# StarFire<sup>™</sup> 7000 and StarFire<sup>™</sup> 7000 Integrated Receiver

Software Update 23-1 Release Notes 6.60T

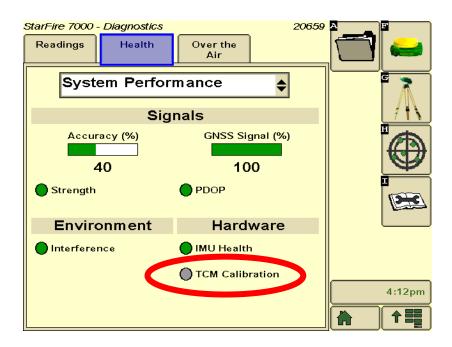
#### **TCM Quality Indicator on StarFire™ Health Page**

The StarFire™ Health page now contains a new indicator for the TCM calibration quality. The background TCM Calibration will compare the current calibration to the background calibration. The comparison will be displayed as a color indicator on the StarFire™ Health page. This indicator will only work once the TCM has been calibrated by either the 2-point method, or the advanced TCM calibration. Once calibrated, the operator will need to drive multiple parallel passes (field operation) before the indicator will populate a color identifying if the calibration is good, marginal, or poor.

- Grey Initializing
- Green OK Calibration
- Yellow Marginal Calibration
- Red Poor TCM Calibration, TCM Calibration Issue, or TCM not calibrated
